Department of Energy

Hydrogen in Piping and Ancillary Vessels Implementation and Closure Plan

Document number: 24590-WTP-RPT-ENG-10-021, Rev 0

24590-WTP-RPT-ENG-10-021, Rev 0
Hydrogen in Piping and Ancillary Vessels
Implementation and Closure Plan

Figure 2

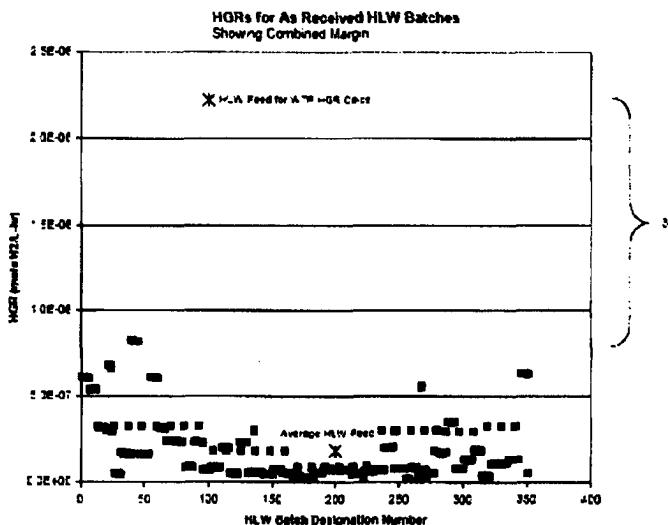
F3-5

Additional analysis is needed to demonstrate the enveloping feeds result in conservative estimates of the hydrogen generation rate at all locations in the process. (See TR 3-1.)

BNI will expand on this and document an evaluation that shows that other key points in the plant representative of the impact of planned processing on the hydrogen generation rate calculation margin have at least the factor of two margin required to bound the correlation uncertainty. To a significant extent this has already been done in the margin, leach, and AN waste analyses (Attachments M, K, and L or 24590-WTP-M4C-V11T-00004), but some results in Table L-5 do not demonstrate adequate margin, additional documentation is required, and some new runs must be performed with the current mass balance, and current feeds. BNI will revise the Hydrogen Generation Rate Calculation with the results of this work.

In addition, in conjunction with Finding 2-6, a distributed HGR will be developed in lieu of the conservative, point estimate currently established by project calculations. BNI will issue an HPAV HGR calculation that will provide the UHGR that spans the expected temperatures ranges of minimum, normal operating, and maximum operating for each system in support of preprocessing for each route. These temperatures will be used to develop HGR distributions for QRA input. In addition, for select systems, cool down times will be calculated for the piping to more realistically model total H₂ generation in long
